Final Report:
Independent Design Review
Celanese Fiber Operations
Superfund Site
Shelby, North Carolina
EPA Region 4

EPA-542-R-11-001
February 2011
www.epa.gov

This independent review aims to determine if the IT P&T system should be restarted, if a modified system should be restarted, or if another type of ground water remedial approach is warranted.

Figure 2. Flow Chart Illustrating Potential Process for Arriving at a Remedy for Diethylene Oxide

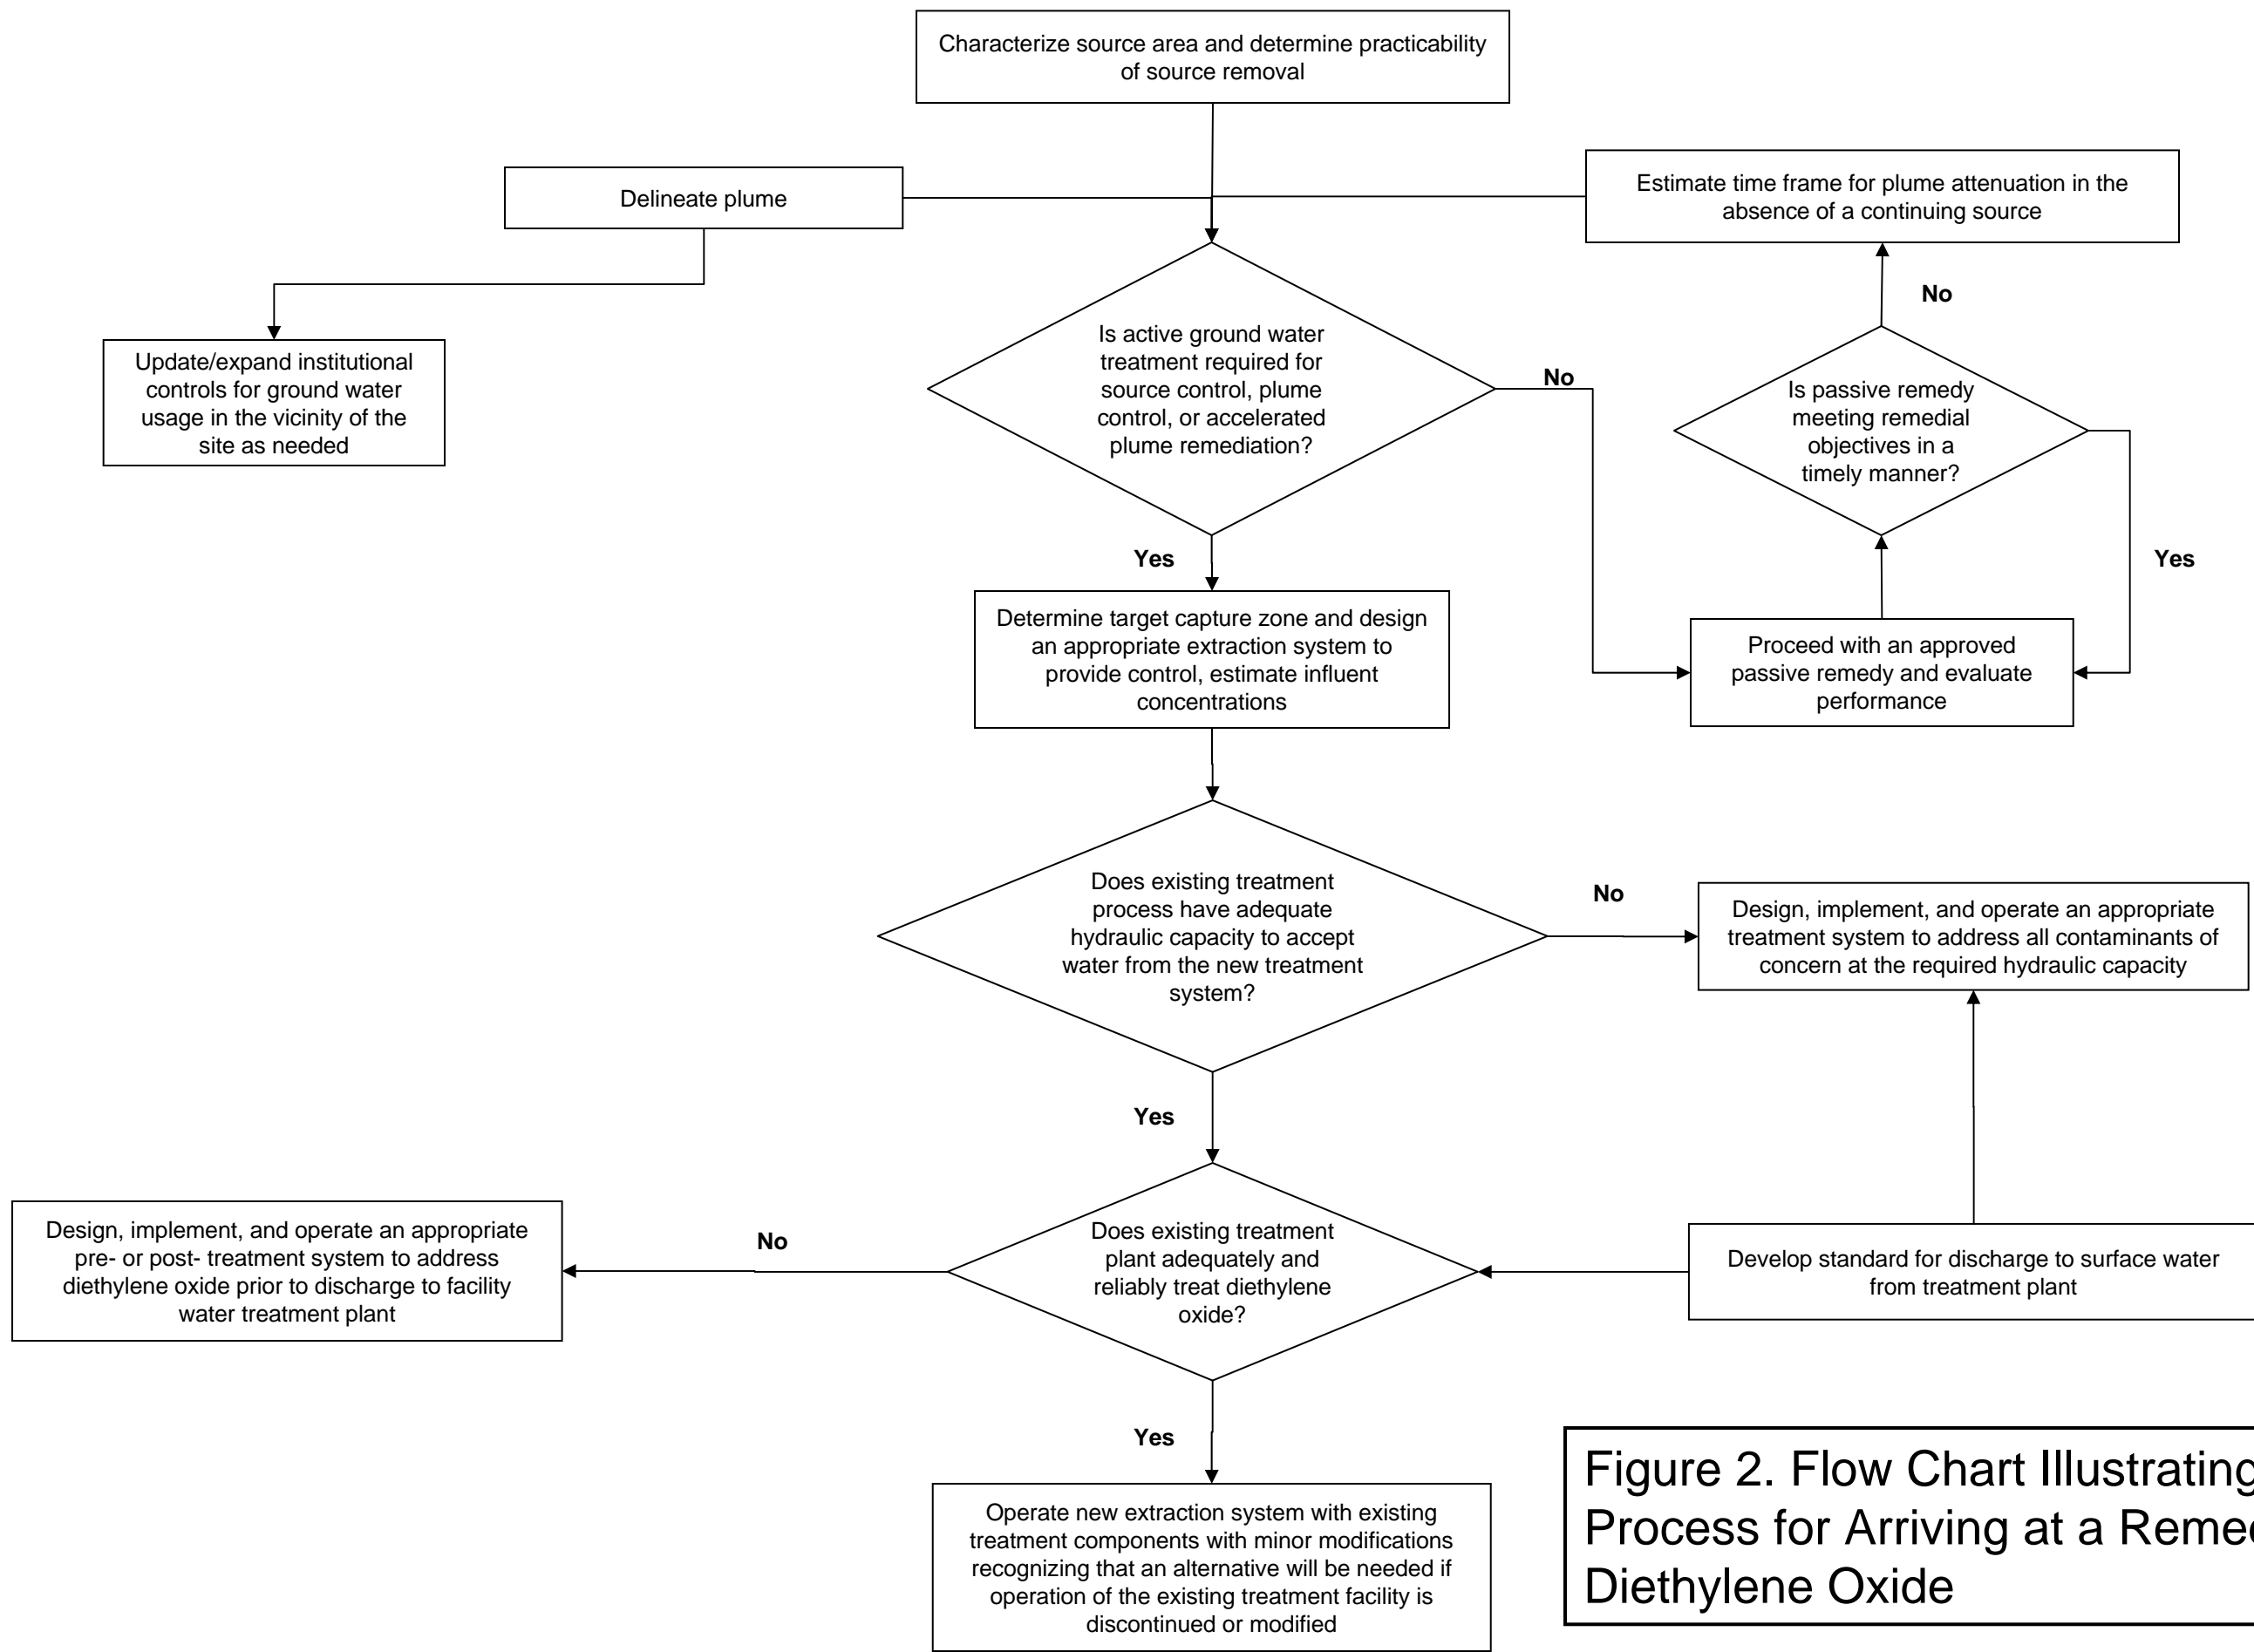
Figure 2 provides a flow chart to illustrate the potential process for arriving at a remedy for diethylene oxide. Consistent with current findings in literature, this flow chart assumes that in-situ remediation will not be appropriate for providing reliable plume control. Source removal, source control, and active plume remediation are considered as is the potential need to expand institutional controls for ground water usage in the vicinity of the site is also indicated.
